Access Compliance Report

Public Rights-of-Way

(Pedestrian Signals)

Intersection ID: N/A	Main Street:	Cross Street: N/A	Location: N/A
ADA ID: B11729F2C1B5	Signal Type: Two Push Buttons-Non APS	Overall Compliance: No	Severity Score: BTN 1:N/A BTN 2: N/A No BTN: N/A
Codes/Mitigation Info/Possible Solution		Field Measurements/Component Compliance

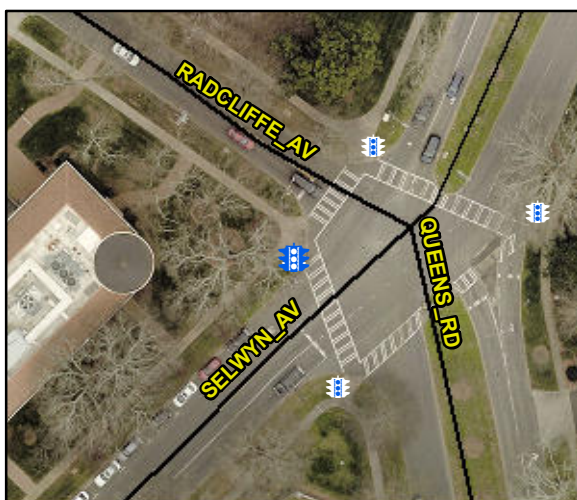
Possible Solutions: Provide PAR As Indicated. Provide Push Button Extension. Provide Clear Space.

PROW/ADA: R404.3, R404.1, R406.2, R404.7.3
